Taronga Zoo Sky Safari

Appendix JJ
Cable Car Clearance
Requirements
RTS Revision 2

TZ Sky Safari Cable Car Revitalization Cable Car Tender Phase

Doc #:	M013_R1
To:	Sky Safari Team
From:	Steve Dorau, SCJ Alliance
Date:	March 24, 2024 April 16, 2025
RE:	Ropeline Profile Recommendations

Figure 1

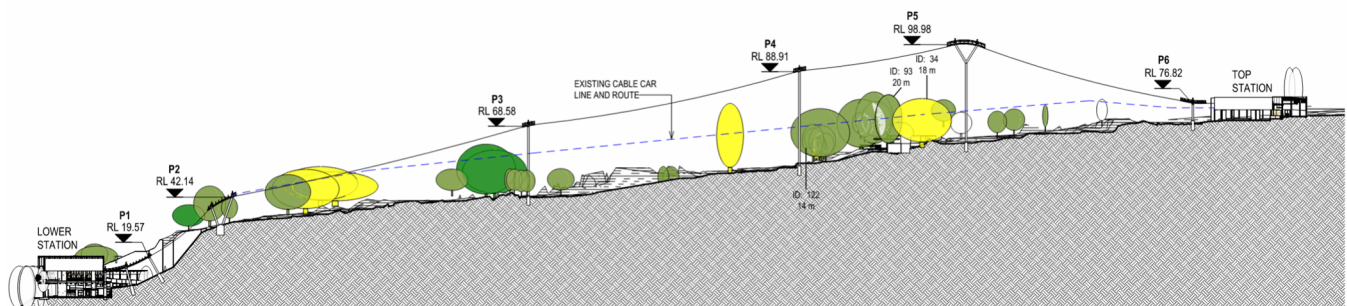
The project team has been carrying the ropeline profile shown in Figure 1. This profile was developed to accomplish the following goals:

- Maintain a clearance of 2.4 m above the primate and elephant barn exhibits as required by the AS4722 ropeway standard
- Maintain a clearance of 4.0 m above pedestrian areas as required by the AS4722 ropeway standard
- Maintain a fire mitigation clearance of 10 m above the Food Court
- Maintain clearance and avoid impacts to the protected hoop pine trees

It should be noted that due to the increase in the cable car cabin size, the cables will likely sag more than the previous Sky Safari cable car system under similar conditions and taller pylons will likely be required to achieve the same result.

SCJ is of the opinion that the existing ropeline profile design is well-suited to the project site, meets the intent of the AS4722 ropeway standard and will result in a successful project.

Figure 2

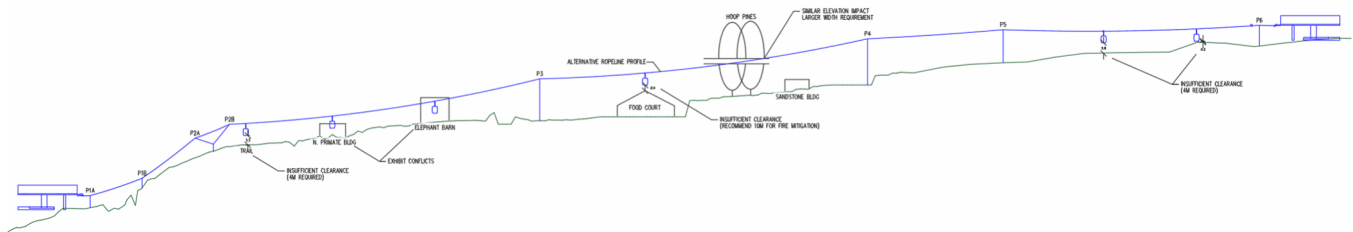
For comparison, SCJ reviewed an alternative concept in which the heights of the pylons for the Sky Safari Revitalization project are kept in conformance with the general height of the previous Sky Safari cable car system. The results of this analysis are shown in Figure 2. It should be noted that the proposed cable car system has larger cabins and requires more width for clearance than the existing system.

It is SCJ's opinion that this alternative is not appropriate for the project site as it fails to meet the requirements of the AS4722 ropeway standard and industry standards in the following ways:

- The clearance above the trail just uphill of Pylon 2 would be just 3.3 m, short of the 4 m requirement
- The revised ropeline profile would impact the Primate Building and Elephant Barn
- The clearance above the Food Court would only be 2.0 m, short of the recommended 10 m of clearance
- The protected hoop pines would be impacted by the wider proposed cable car system as the cable cars pass between the trees at greater width than the current system
- The area between Pylons 5 and 6 would have insufficient clearance for pedestrians and zoo staff as a minimum of 4 m is required

SCJ is of the opinion that the alternative ropeline profile shown in Figure 2 is not suited to the project site and would not meet the requirements of the AS4722 ropeway standard.
